August 24, 2020
GO2-20-118

Subject: **COLUMBIA GENERATING STATION, DOCKET NO. 50-397
RESPONSE TO REQUEST FOR ADDITIONAL INFORMATION
RELATED TO EXIGENT LICENSE AMENDMENT REQUEST FOR
CHANGE TO TECHNICAL SPECIFICATION 3.8.7 DISTRIBUTION
SYSTEMS – OPERATING**

RESPONSE TO REQUEST FOR ADDITIONAL INFORMATION

MAIN ONE LINE DIAGRAM

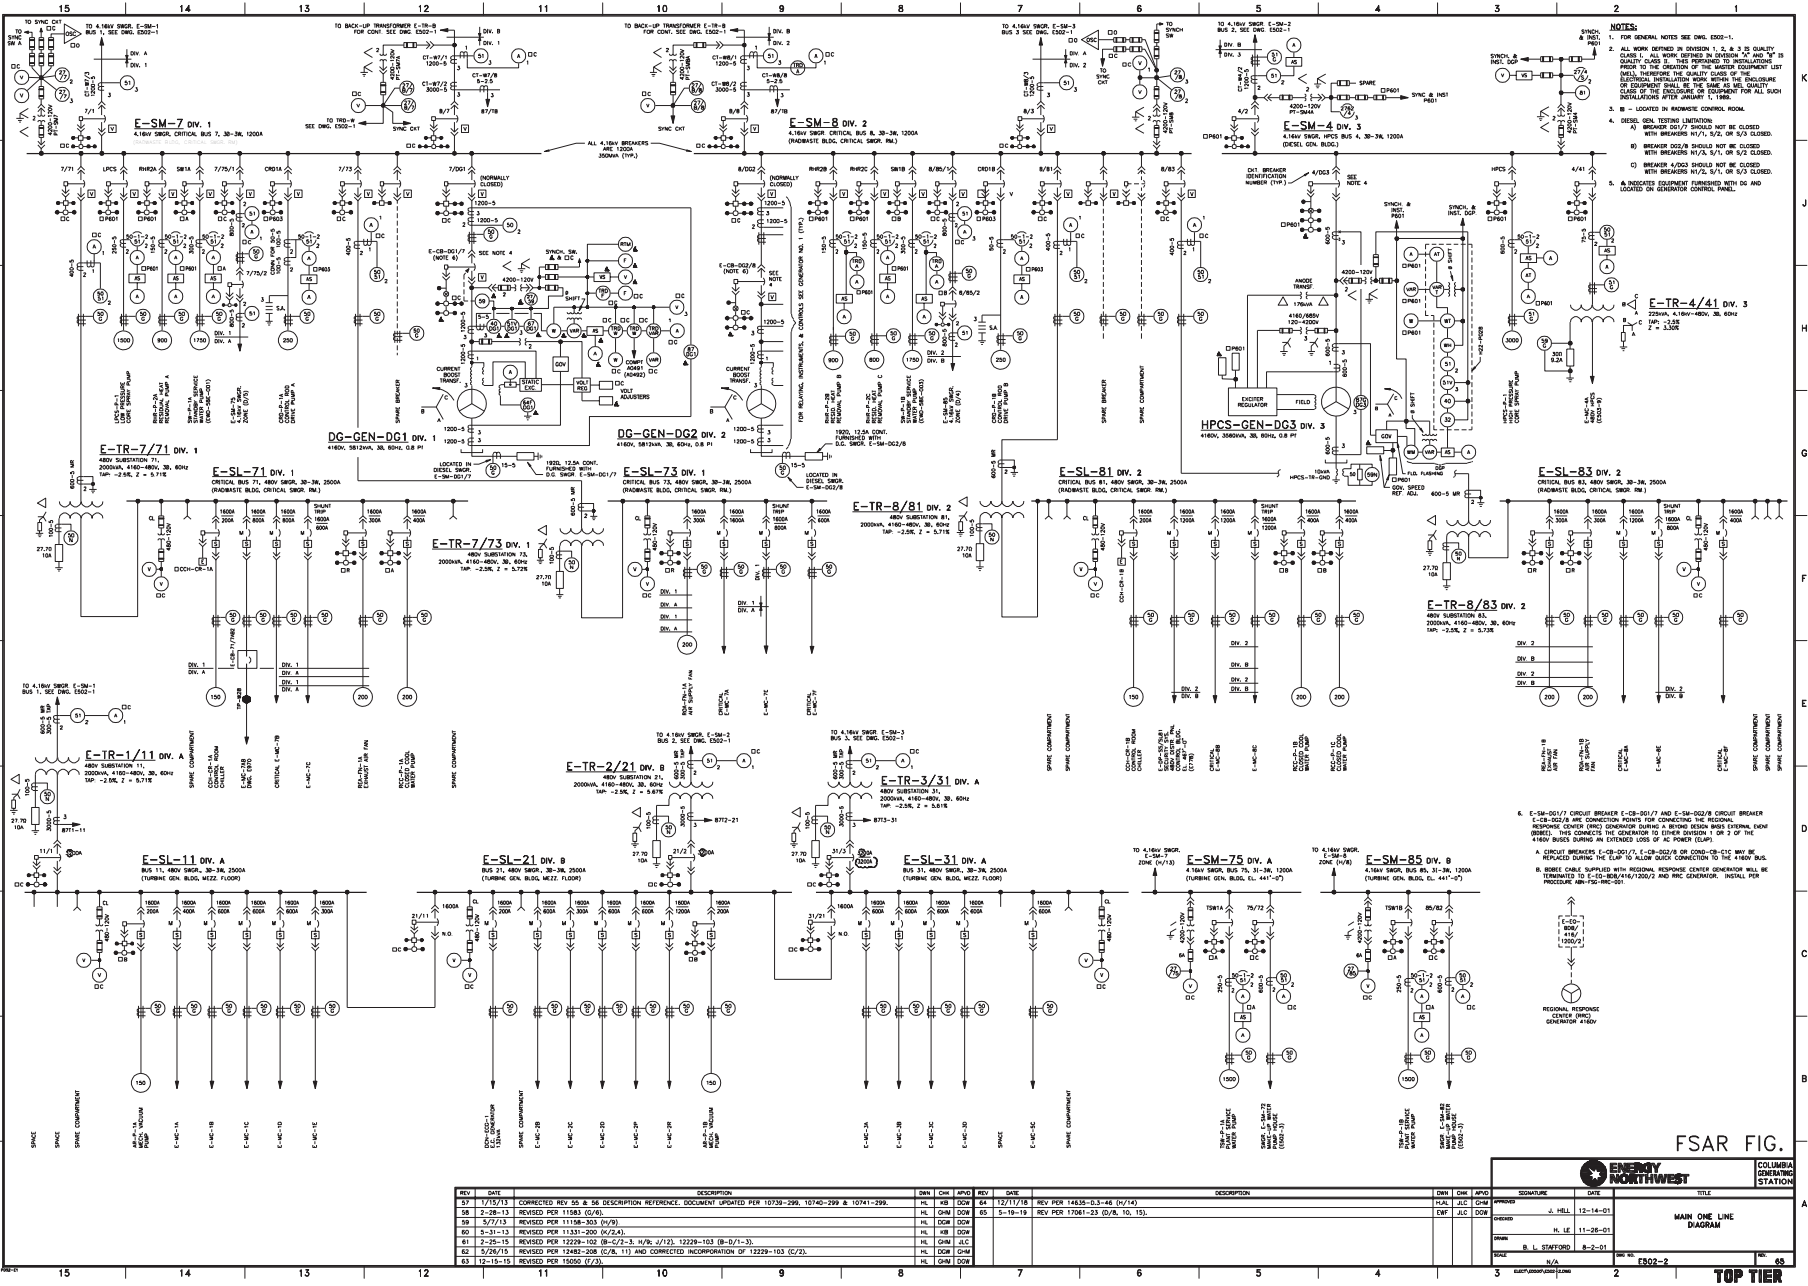
On Page 2 of Enclosure 1 of the LAR, the table for "AC Power Distribution Subsystems" shows the various safety-related buses and power panels for each division. For a better understanding of line-up of the distribution subsystems, please provide requisite single line drawing for each division showing the distribution transformer connections between various buses and panels listed in the table.

The list of requested drawings, which show the AC Power Distribution subsystems with transformer connections are provided below and are placed in Attachment 1 to this Enclosure.

1. E502-1 – Main One Line Diagram (depicts feeds to Divisions 1-3 4160 V switchgear)
2. E502-2 – Main One Line Diagram (depicts Divisions 1-3 4160 V switchgear, SM-7, SM-8, SM-4 feeding 480 V switchgear SL-71, SL-73, SL-81, SL-83 feeding 480V Motor Control Centers (MCCs) 7A, 7B, 7F, 8A, 8B, 8F and 4A)
